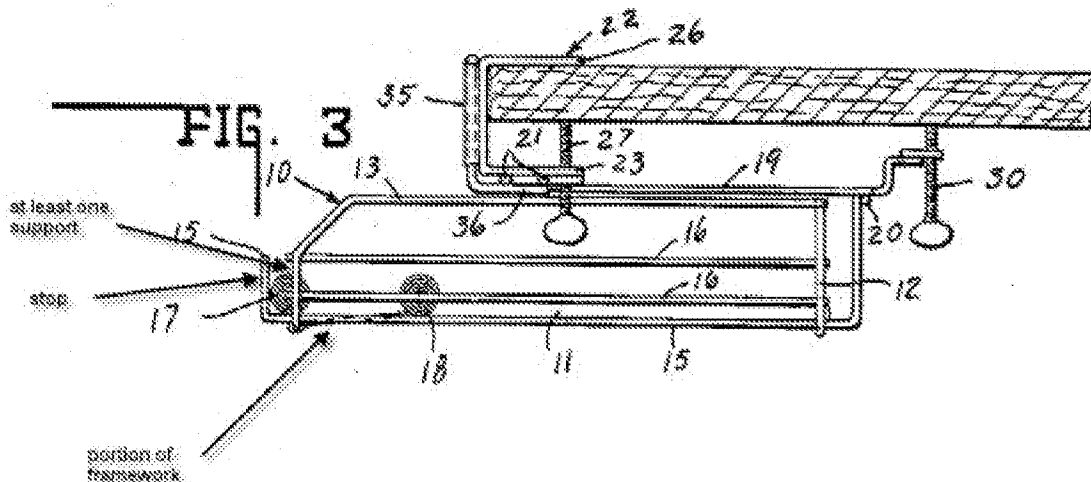
Claim 56 is rejected under 35 U.S.C. 102(b) as being anticipated by Dickson (US 3007580). Dickson discloses a shelf structure configured to rest on and engage a shelf, the shelf structure comprising:

a front member 21 and at least two other members 21, 20 rearwardly spaced from the front member and, together with the front member, defining a first plane above the shelf and configured to support additional shelving above the first plane;

a framework 15 defining a second plane disposed below the first plane and configured to support a plurality of beverage containers between the first and second planes;

and at least one support (labeled below) connecting at least the front member and the framework;

wherein at least a portion of the framework (labeled below) extends at least forward of a projection of the front member 21, the projection including with a stop (labeled below) extending in a direction from the second plane toward the first plane;

members 23 on the front and at least one of the other members configured to fix the framework under another structure.

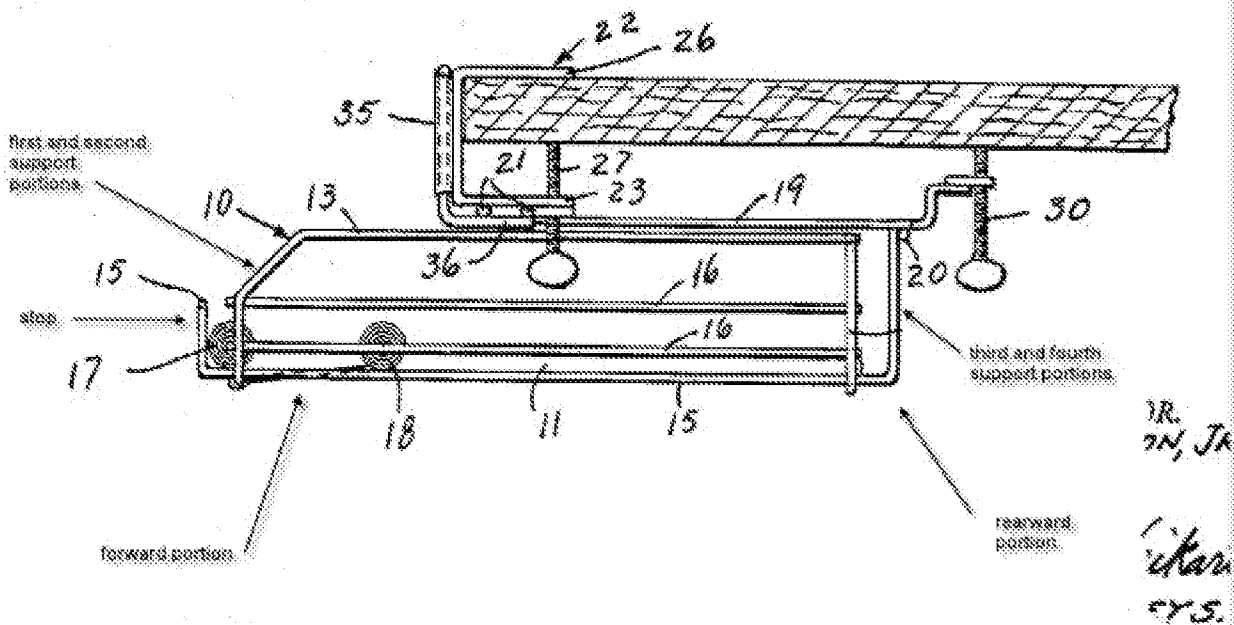
Claims 57 and 59 are rejected under 35 U.S.C. 103(a) as being unpatentable over Dickson (US 3007580) in view of Lockwood (US 4732282). Dickson discloses a shelf fastened under a structure 32 by fasteners 27, the shelf comprising:

a support assembly having a forward portion (labeled below) and a rearward portion (labeled below), the support assembly defining a support surface (not numbered, but shown in figure 3) configured to support a plurality of cylindrical beverage containers;

a stop (labeled below) disposed at the forward portion of the support assembly;

first and second support portions (labeled below) disposed at the forward portion of the support assembly, the first and second support portions including upper ends, respectively, adapted to be disposed above the plurality of cylindrical beverage containers supported on the support surface;

third and fourth support portions (labeled below) disposed at the rearward portion of the support assembly, the third and fourth support portions including upper ends, respectively;

at least a third aperture (not numbered, but shown as the aperture for the fastener 30 in figure 3) disposed adjacent the upper ends of the third and fourth support portions, respectively, the third aperture being configured to receive a fastener 30 for supporting the rearward portion of the support assembly from a shelf above the support assembly; and

wherein the third aperture is spaced from a rearward most portion 20 of the rearward portion of the support assembly such that cylindrical beverage containers can be placed onto the rearward portion of the support assembly when the third aperture is connected to a shelf disposed above the support assembly by fasteners;
